Re: DA2021/0953 - 52 Abbott Road, North Curl Curl

In reference to the above application under assessment by Council and specifically in response to the correspondence dated 19 August;

DRIVEWAY SECTION
SCALE 1:50

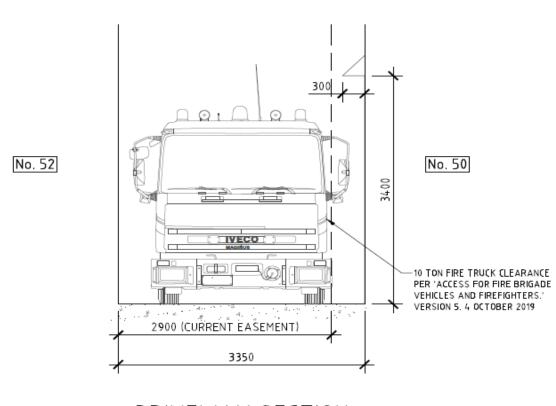
"...In accordance with the above DCP, the minimum width of the accessway must be 3.5m However, the proposed accessway is about 2.8m wide. As such, the application cannot be supported due to the clause C1 of Warringah Council DCP."

The narrowest point between the existing residences at 50 & 52 Abbott Road is 3.35m clear width. An eave from No. 50 reduces this clear width at a height of 3.4m from drive level. An annotated sectional detail **(SHEET-SK1)** has been attached to this letter for your review.

AS2890.1 notes a minimum width of 3.0m for 'straight roadways'.

The proposed accessway is straight and flat with a clear line of sight. A passing bay is included on the location and located 10m from the non-compliant 'pinch point'.

NSW Ambulance 'Vehicle and Stretcher Dimensions - 01-04-2019' notes a maximum height of 'Bariatric Specialist Ambulance' of 3.2m including aerial and width of 2.6m including mirrors. This is the largest vehicle held by NSW Ambulance and the more common 'Sprinter' type vans are substantially smaller in scale. All listed NSW Ambulance vehicles would be able to safely access the rear lot via the existing accessway.

In reference to the advice by Council, in light of the relevant Standards and following a review of the subject site, it is assessed that an accessway width of 3.2m although non-compliant with numerical aspects of the DCP, satisfies all relevant engineering performance criteria. The circumstances are therefore appropriate for the council to be flexible in applying the numerical control.
